A d d e n d u m

Iowa Department of Transportation
Office of Contracts

B.O.	Proposal ID	Proposal Work Type	County	Project Number	Addendum
402	39-7457-604	Buildings - Renovation	Guthrie	STP-ES-7457(604)--8I-39	21aug402.a02

STUART DEPOT COMMUNITY BUILDING
PHASE 3 STP-ES-7457(604) - 81-39/ 10-STPES-115
 204 E. Front Street Stuart, IA GUTHRIE COUNTY

E4.4
 DATE: MARCH 2011
 ELEC DETAILS
 SHEET 10 OF 10E

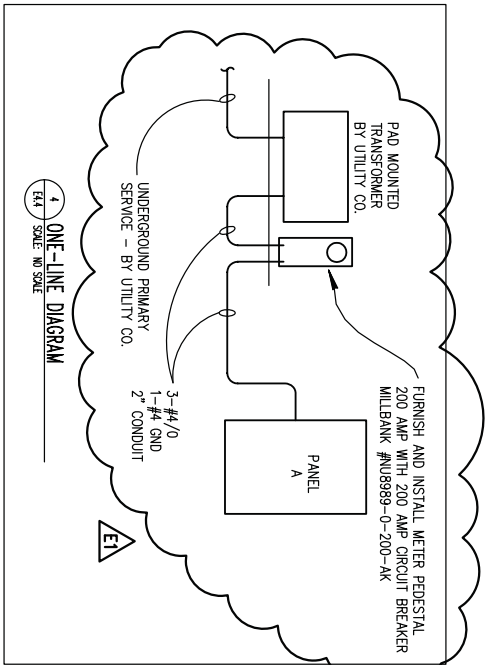
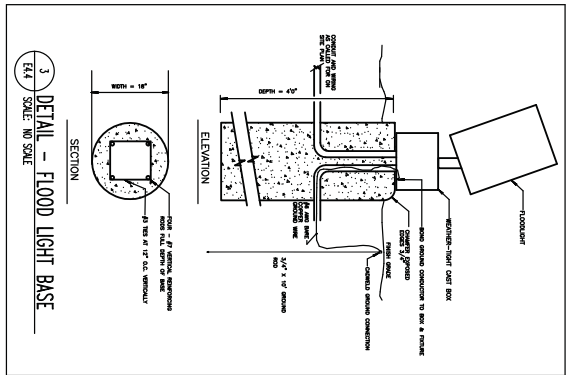
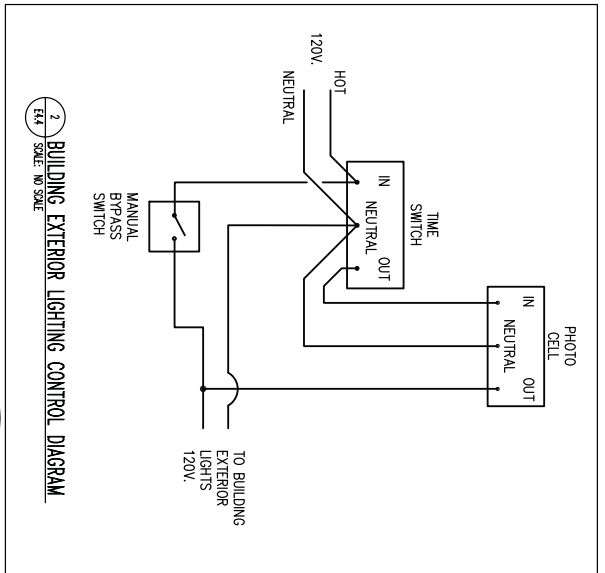
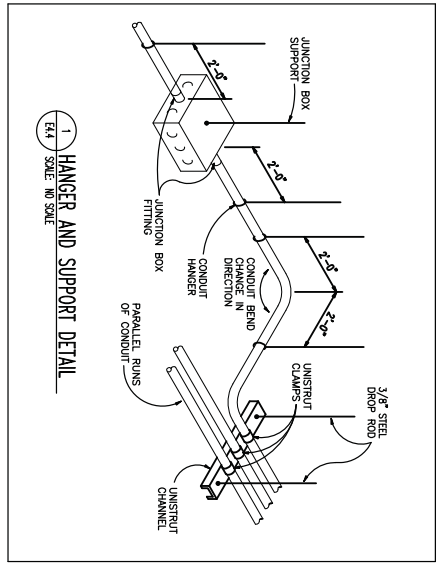
Delete Sheets E0.1 and E4.4 and replace with the attached Sheets E0.1 and E4.4.

Municipal Electric Utility Company will install pad mounted transformer and primary underground electrical service to pad mounted transformer.

Contractor shall install meter pedestal adjacent to pad mounted transformer and shall install underground secondary electrical service from pad mounted transformer to meter pedestal and to the panel board in the building.
